Agenda Item # 5

SUB-002995-2024

Chassidy's Woods Subdivision

CHASSIDY'S WOODS SUBDIVISION

DETAIL SITE PLAN

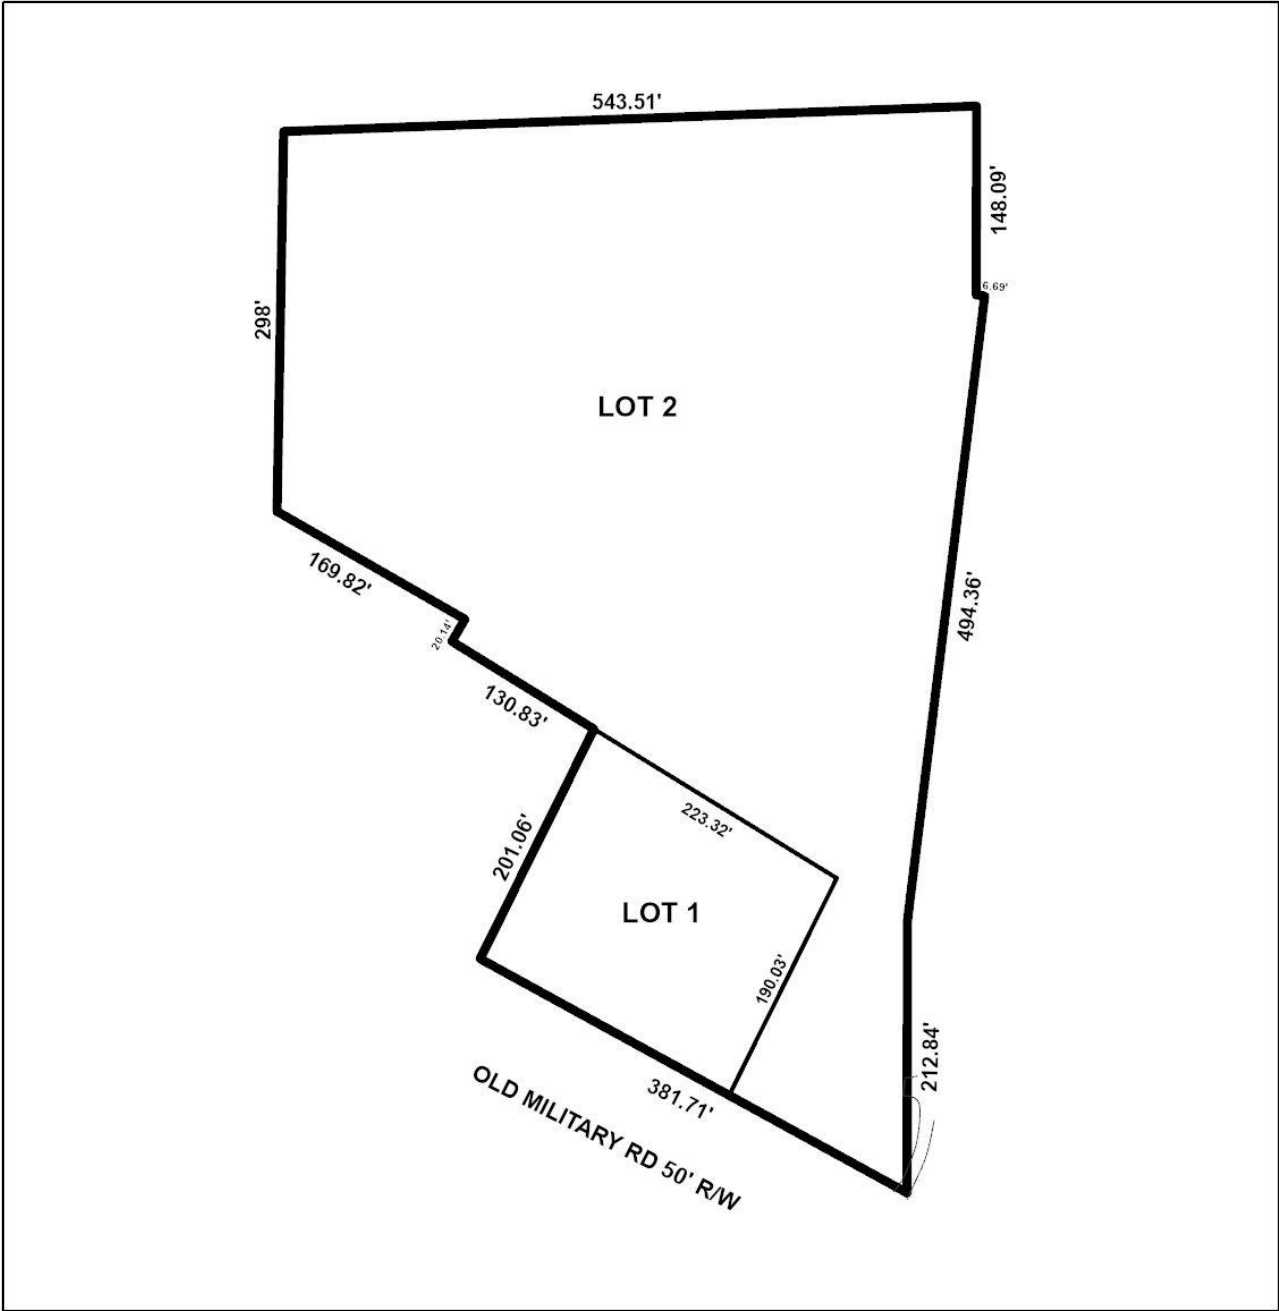
- E. Show and label the POC and provide the tie between the POC and the POB.
- F. The written legal description does not seem to match the bearings and distances in the Plan view.

- G. Revise the spelling of "COMER" in the written legal description to "CORNER".
- H. There are two (2) different listings for a POINT OF BEGINNING in written legal description.

- I. Provide reference, on the map and the description, to a monumented corner.
- J. Provide and label the monument set or found at each subdivision corner.

- K. Add a graphic scale.
- L. Revise the plat to label each lot with its size in acres and square feet, or the furnishing of a table on the Plat providing the same information.

- M. Add a signature block for the Planning Commission, Traffic Engineer, and City Engineer.
- N. Add a note to the SUBDIVISION PLAT stating that as shown on the 1984 aerial photo LOTS 1 and 2 will receive historical credit of existing (1984) impervious area towards stormwater detention requirement per Mobile City Code, Chapter 17, Storm Water Management and Flood Control) as follows: LOT 1 – NONE AND LOT 2 – NONE.

Both proposed lots have frontage along Old Military Road, a minor street without curb and gutter requiring a 60-foot right-of-way width. The preliminary plat illustrates a non-compliant 50-foot right-of-way for Old Military Road. If approved, the Final Plat should be revised to illustrate compliant right-of-way and dedication sufficient to provide 30 feet from the centerline of Old Military Road, as was required in 2007 for a subdivision adjacent to the site.

Lots 1 and 2, as proposed, exceed the minimum size requirements for lots served by public water and sanitary sewer in an R-1, Single-Family Residential Suburban District. The size of each Lot, however, is not labeled in either square feet or acres, as required by Section 5.A.2(e)(4) of the Subdivision Regulations. If approved, the Final Plat should be revised to label the size of each Lot in both square feet and acres, adjusted for any required dedication; or provision of a table on the Final Plat with the same information, will suffice.

The survey does not depict a minimum front yard setback line for either Lot. A minimum 25-foot front yard setback is required along all frontages for both Lots, in compliance with Article 2 Section 64-2-5.E. of the Unified Development Code for lots zoned R-1 in the Suburban sub-district. If approved, the Final Plat should be revised to illustrate a compliant setback along Old Military Road, adjusted for any required dedication.

Lot 2 exceeds the maximum width-to-depth ratio of 3.5 times allowed under the Subdivision Regulations. As such, if approved, a waiver of Section 6.C.3 would be necessary. Additionally, the survey depicts the proposed Lot 2 as an irregularly shaped lot. Per Section 6.C.1 of the Subdivision Regulations, the size, shape, and orientation of lots should be compatible and appropriate with the location of the subdivision and the type of development and use contemplated. It appears the parcel has been used in its current configuration for some time and large irregularly shaped properties are not uncommon in the vicinity. As such, if approved, a waiver of Section 6.C.1 may be appropriate.

1. Provision of dedication sufficient to provide 30 feet from the centerline of Old Military Road if the existing right-of-way is not 60 feet in width;

2. Provision of a label with the lot sizes in both square feet and acres, or provision of a table on the Final Plat providing the same information, adjusted for dedication;

3. Revision of the Final Plat to illustrate a minimum 25-foot front yard setback along Old Military Road, in compliance with Article 2 Section 64-2-5.E. of the Unified Development Code for lots zoned R-1 in the Suburban sub-district, adjusted for any required dedication;
